MOUNTING THE ADAPTER CABLE START RELAY

AFFECTED MODELS:

2026 990 RC R

2026 990 RC R TRACK

Fig. 1 – Remove the 990 RC R Track seat fairing

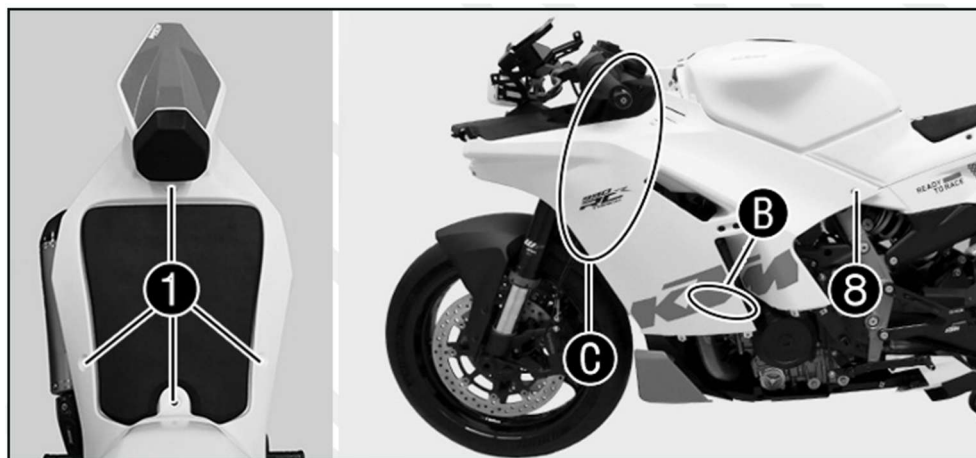
- 990 RC R: Remove the seat and remove the battery.
- 990 RC R Track:
 - Remove screws (1) of the seat fairing (see Fig.1).
 - Remove screws (8) of the side spoiler (left/right) (see Fig.1).
 - Carefully push the side spoiler to the side, lift and remove the seat fairing at the rear (see Fig. 2). Remove the battery.
- Pre-assemble the adapter cable, retaining plate and relay 07 (see Figs.3 and 4).
- Unplug the start relay, mount the retaining plate and adapter cable (see Figs. 5 and 6).
- Fix the adapter cable next to the battery box with the cable tie (see Fig.7)
- Connect adapter cable plug, start relay plug and start relay (see Fig.8).
- Assemble and connect the battery (see Fig.8).
- Check plug connections for tightness.
- Complete the vehicle, set the time and date and conduct a test drive.

Fig. 5 – Retaining plate position on the battery box (middle flap outside)

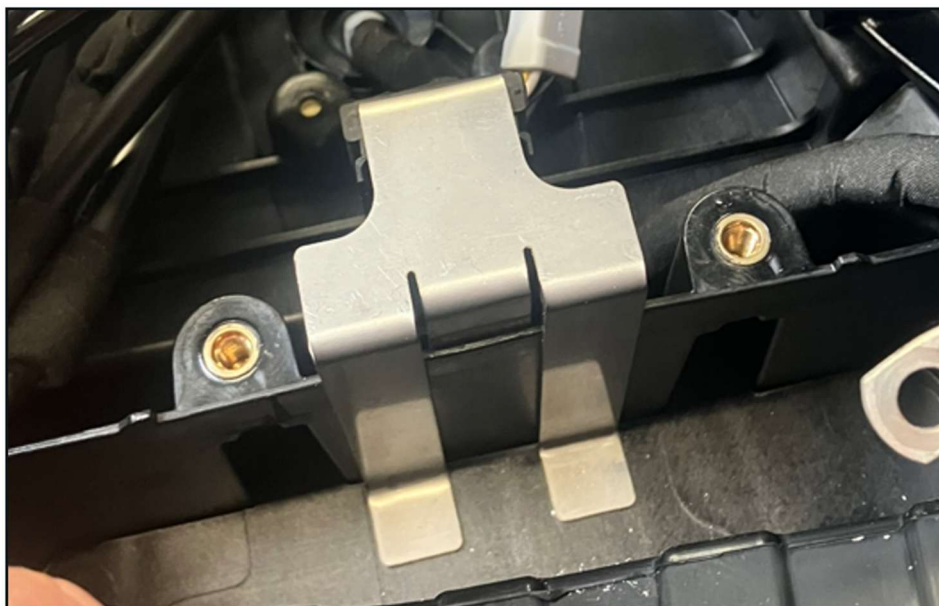
Carefully remove the cover cap of the start relay, reserve fuses fall out easily. The mounting position of the battery fixes the relay retaining plate.
